## SUNDRY NOTICES AND REPORTS ON WELLS

7. If Unit or CA/Agreement, Name and/or No.  
NMNM1118088. Well Name and No.  
MCKITTRICK 11 FEDERAL 89. API Well No.  
30-015-33990-00-S110. Field and Pool, or Exploratory  
INDIAN BASIN-UPPER PENN ASSOC11. County or Parish, and State  
EDDY COUNTY, NM

OXY USA WTP LP - Proposed  
McKittrick 11 Federal #8  
API No. 30-015-33990

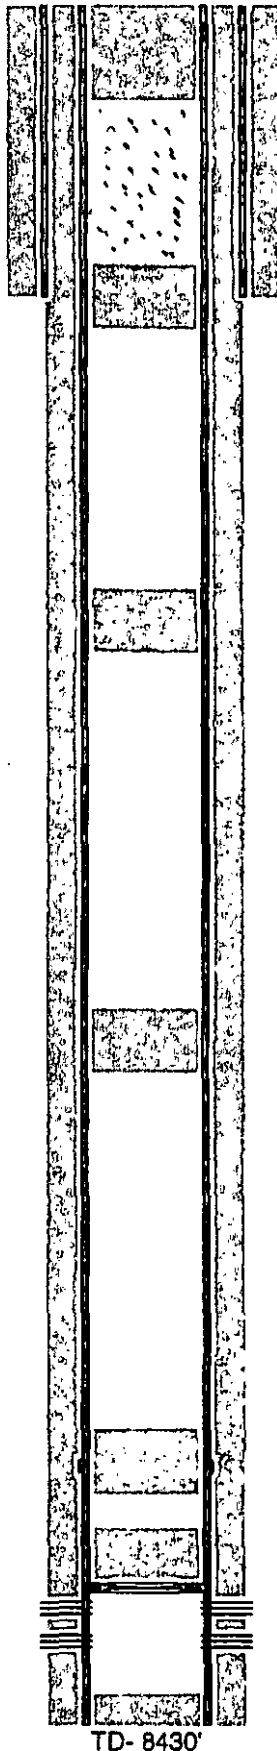
7684-7384

3100-2910

3 Pump cmt from 1550' to surf.

\*\* BLM REVISED \*\* BLM REVISED \*\* BLM REVISED \*\* BLM REVISED \*\* BLM REVISED \*\*

Combine  
Plugs due  
to cave &  
Capitan Reef.

3100-2910  
30sx @ 3150-3020' WOC-Tag  
(Top Bone Spring 2960)

7684-7364'  
65sx @ 7485-7200' WOC-Tag  
T. Wolfcamp at 7634

1550  
100sx @ 450'-Surface

Surf  
30sx @ 1550-1435' WOC-Tag
